Planning Assessment Officer Report

PA2604264, 518-522 Chapel
Street, SOUTH YARRA

Planning Assessment Officer Report
Development Assessment

Figure 13: Proposed south elevation showing indicative ACZ1 encroachment (left)

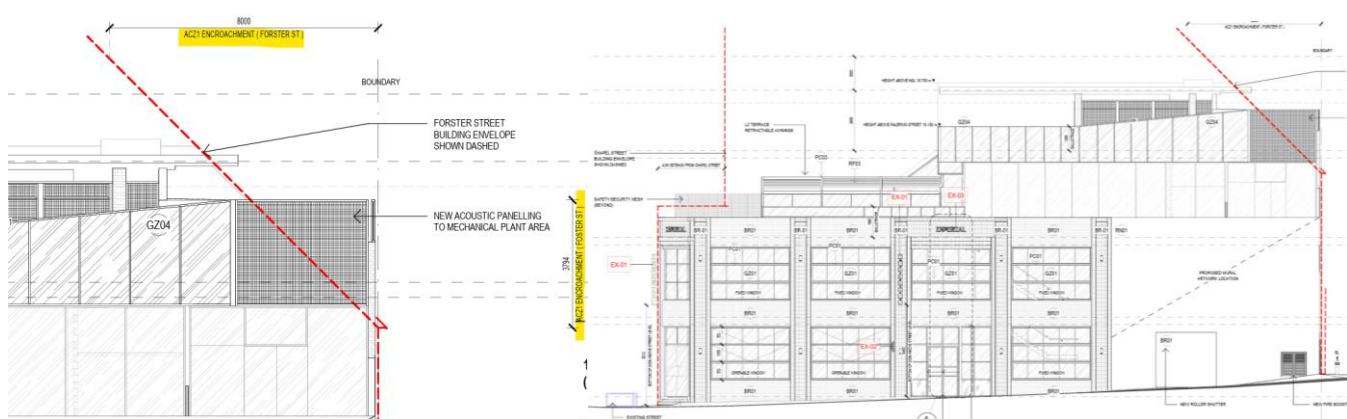
58. The ACZ1 variations are considered modest and occur on a secondary interface backing onto Forster Street. Importantly, Forster Street functions as a service lane and forms a transition to the residential area beyond. The built form response ensures that amenity impacts (including overlooking and visual dominance) are limited. The overlooking drawings specifically showing the interaction between the rear of the proposed built form to 1 Palermo Street (nearby residential dwelling) demonstrate that impacts onto neighbouring properties have been appropriately considered and addressed.

59. DTP therefore finds that the departures from the ACZ1 controls are acceptable and do not compromise the objectives of the built form controls.

Figure 17: Proposed signage on west and southwest elevations

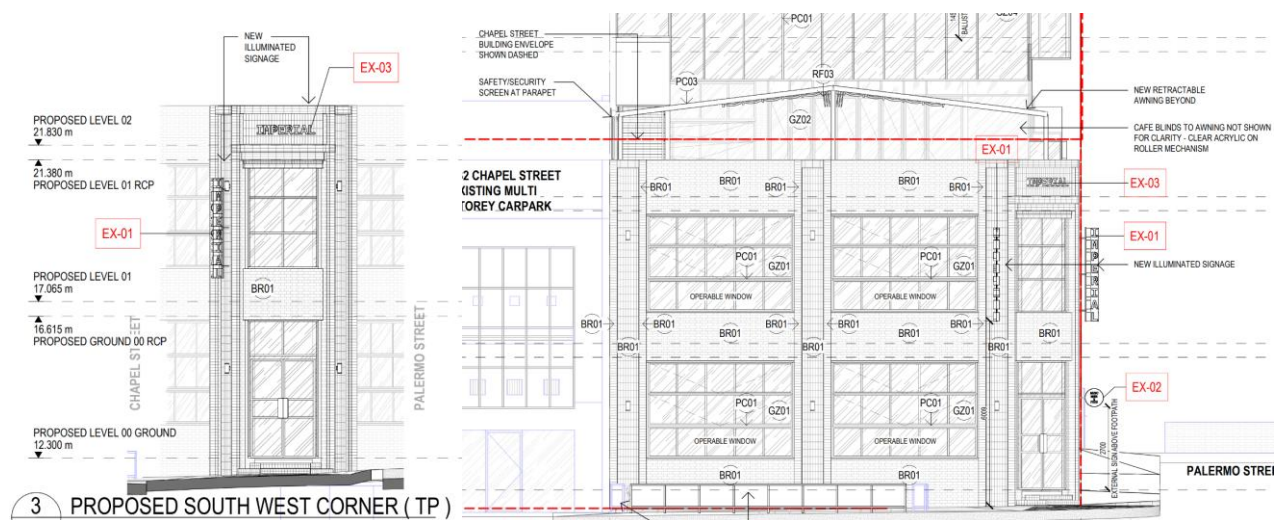
68. The proposed signage is consistent with the established character of Chapel Street and provides appropriate business identification within the Chapel Street Activity Centre. Having regard to the site's context, zoning and the surrounding streetscape, the signage is modest in scale (cumulative signage area of 6.78m²) and consistent with the prevailing signage character of the area.
69. The signage is appropriately located at key entry points to provide clear identification and wayfinding. Positioned away from residential interfaces, the illuminated signage is not expected to result in adverse amenity impacts.
70. The sign structures have been designed to respond to the building façades and will not detract from any important architectural features. Any illumination will not adversely affect pedestrian or vehicular safety, nor the amenity of nearby residents.

Figure 18: Adjoining residential dwelling showing existing shadow in red and additional shadow in green and purple (left)

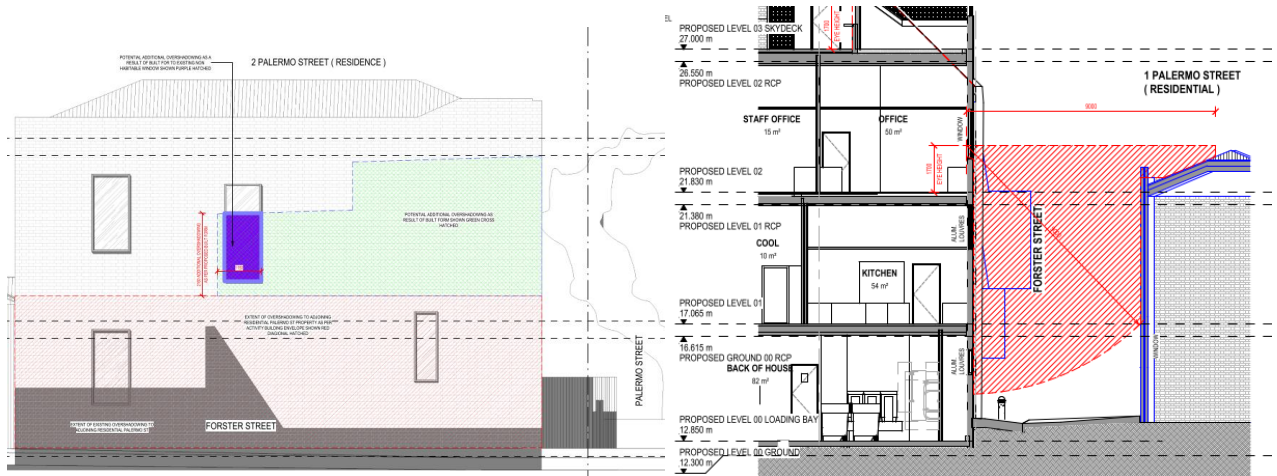
80. One window of the dwellings western elevation is identified to be affected by additional shadow impacts. The window has been identified as a non-habitable room window in accordance with the submitted architectural drawings. While residents of 1 Palermo Street state that the window provides some daylight to adjoining areas, which DTP acknowledges, it does not change the planning assessment of the room's classification for the purposes of applying overshadowing controls.

81. The shadow diagrams show that under the revised design (height reduction via Section 57A Amendment), the additional height to the built form only partially overshadows the window at 3:00pm (22 September) (refer Figure 18). Overall, the proposal has been designed to respond to both the massing controls of the ACZ1 while considering impacts to residential properties to the rear. The additional shadow onto a non-habitable room is considered acceptable within the planning context and site constraints.

82. Potential overlooking impacts from the subject site onto 1 Palermo Street are minimised through the restriction of windows on the rear elevation and setback of level 3 from the residential interface. The office space includes three windows at an approximate height of 1.5m and negligible sightlines into habitable spaces of 1 Palermo Street.

Figure 20: Proposed Level 3 acoustic screening and treatment types

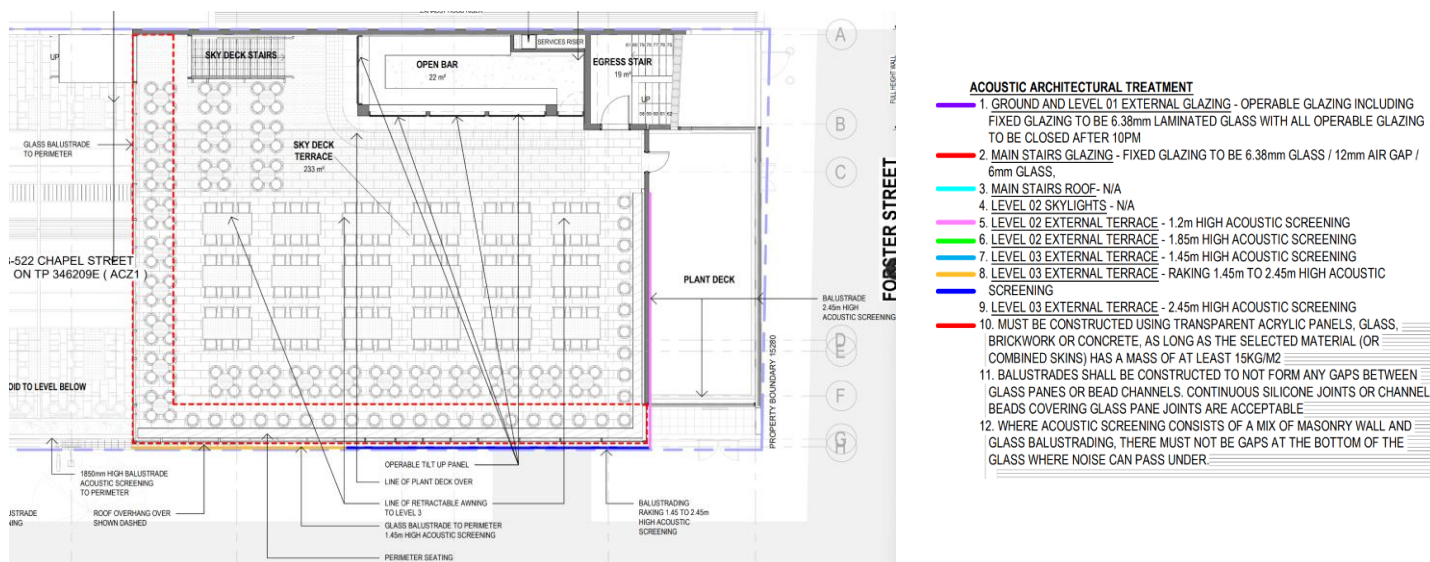
88. Noise will be managed through acoustic screening, sealed glazing closed after 10.00pm, calibrated noise limiters, restrictions on hire-in equipment, and careful loudspeaker placement away from residential interfaces (refer figure 19).

89. To further investigate the acoustic impacts on site, a condition will be placed on the planning permit requesting that post-occupation acoustic testing be conducted and in accordance with the endorsed acoustic plan prepared by Enfield Consultants and dated 11 June 2026.
